## Preliminary Plan Data Table and Checklist

Plan Name: George A. Davis Subdivision				
Plan Number: 1-06013				
Zoning: R-60				
# of Lots: 3				
# of Outlots: 0				
Dev. Type: 3 one-family detached dwelling units				
PLAN DATA	Zoning Ordinance Development Standard	Proposed for Approval on the Preliminary Plan	Verified	Date
Minimum Lot Area	6,000 sq.ft.	11,900 sq.ft. is minimum proposed	<i>Duvil</i>	Jan. 6, 2005
Lot Width	60ft.	Must meet minimum	<i>Duvil</i>	Jan. 6, 2005
Lot Frontage	25 ft.	Must meet minimum	<i>Duvil</i>	Jan. 6, 2005
Setbacks				Jan. 6, 2005
Front	25 ft. Min.	Must meet minimum	<i>Duvil</i>	Jan. 6, 2005
Side	8 ft. Min./ 18 ft. total	Must meet minimum	<i>Duvil</i>	Jan. 6, 2005
Rear	20 ft. Min.	Must meet minimum	<i>Duvil</i>	Jan. 6, 2005
Height	35 ft. Max.	May not exceed maximum	<i>Duvil</i>	Jan. 6, 2005
Max Resid'l d.u. or Comm'l s.f. per Zoning	5 dwelling units	3 dwelling units	<i>Duvil</i>	Jan. 6, 2005
Site Plan Req'd?	No	No	<i>Duvil</i>	Jan. 6, 2005

RE: Preliminary Plan No. 1-06013  
George A Davis Subdivision

**1-06013**

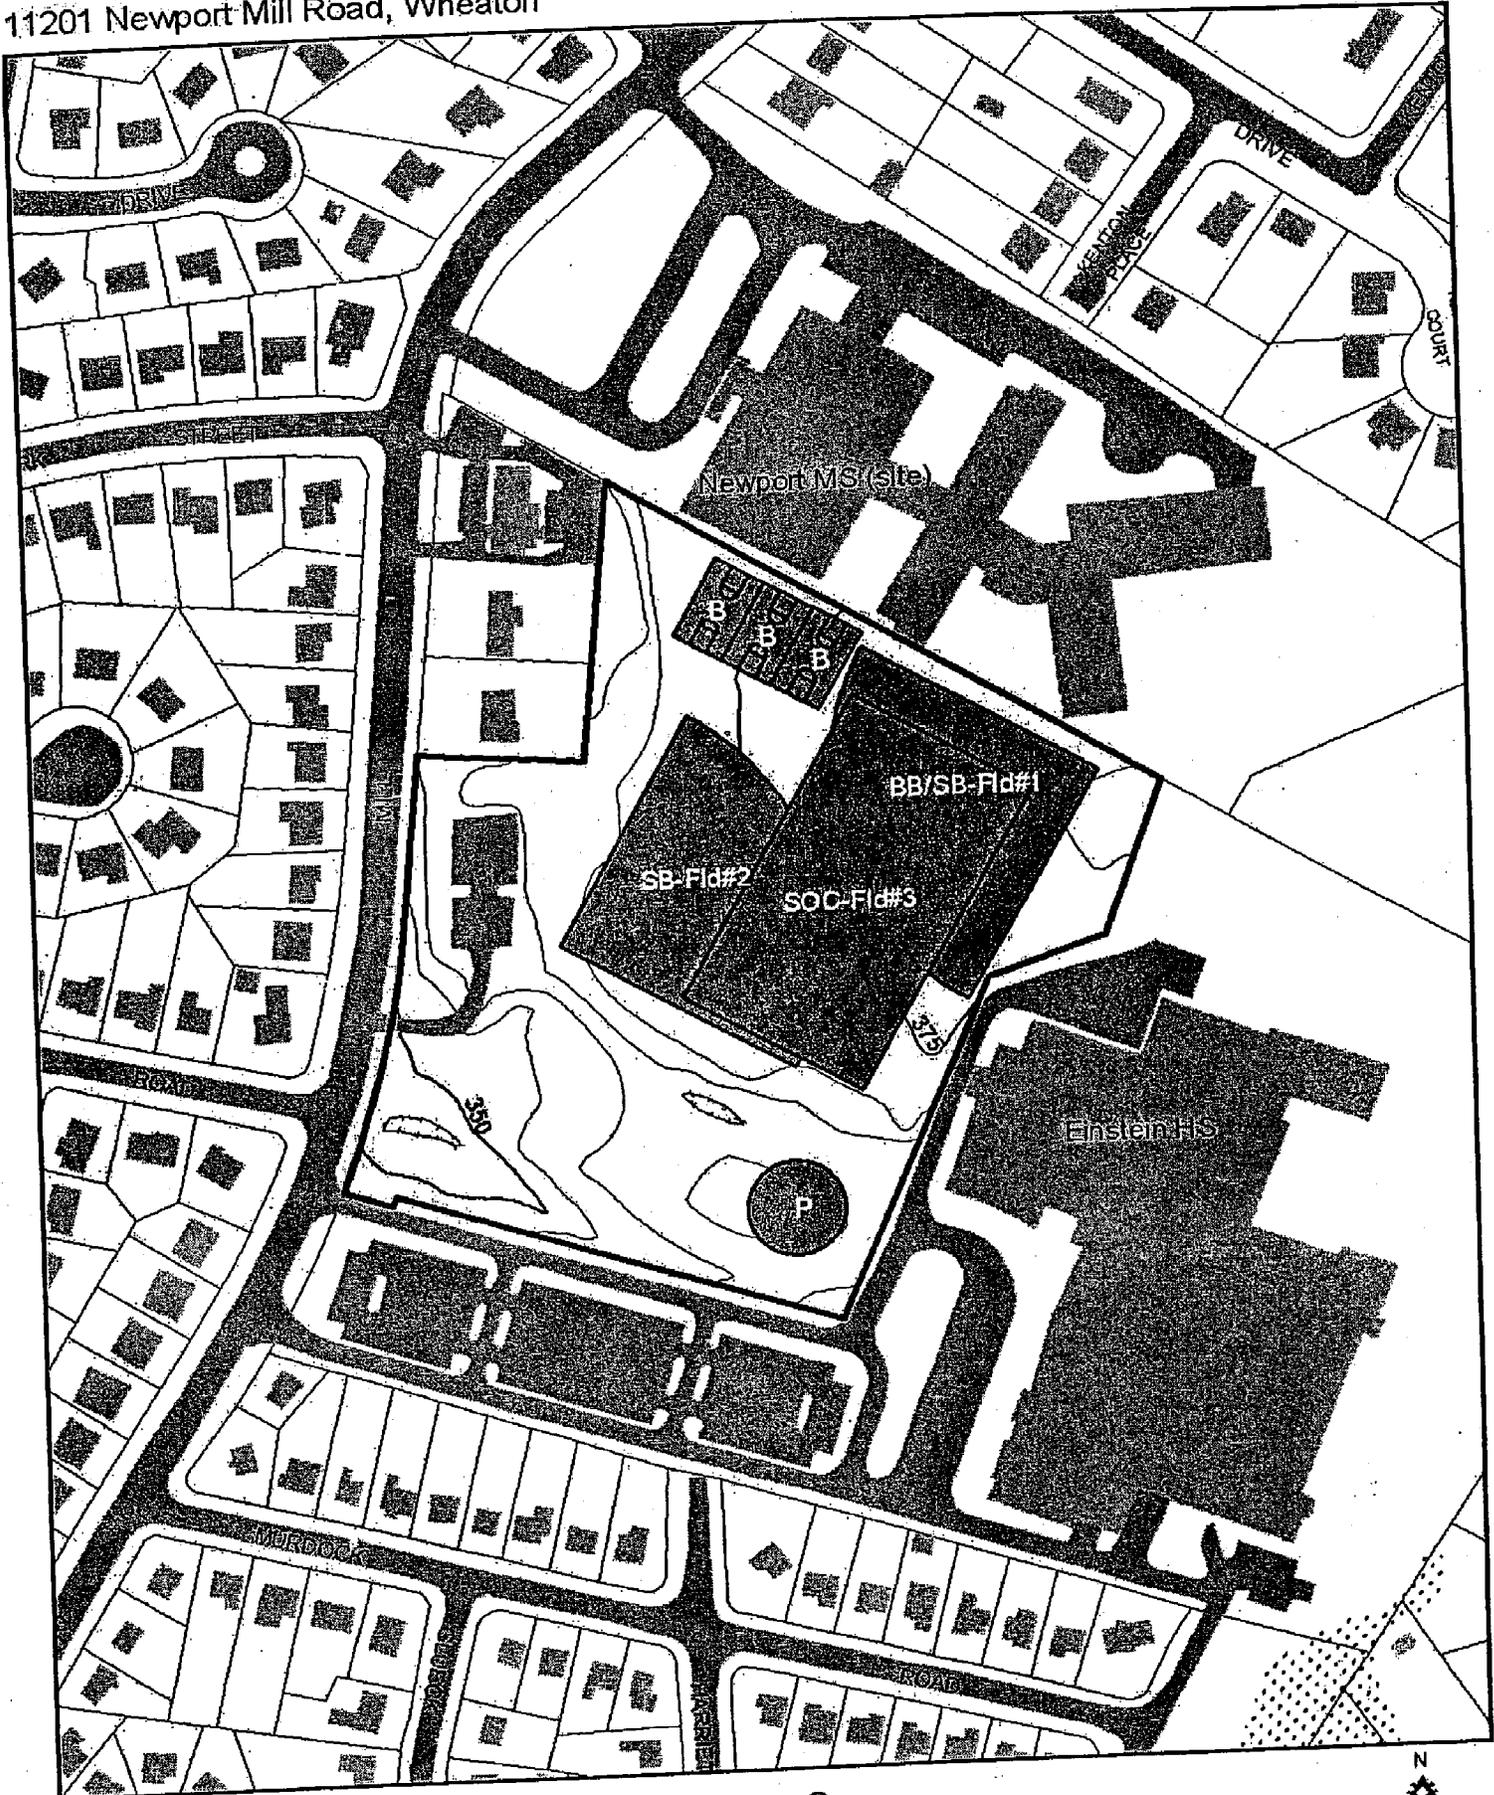
- No disturbance of trees and other vegetation on adjacent parkland. No grading onto parkland.
- Applicant to notify homeowners of existence of adjacent Local Park and active recreational facilities thereon. Notice to include possibility of future improvements to park.
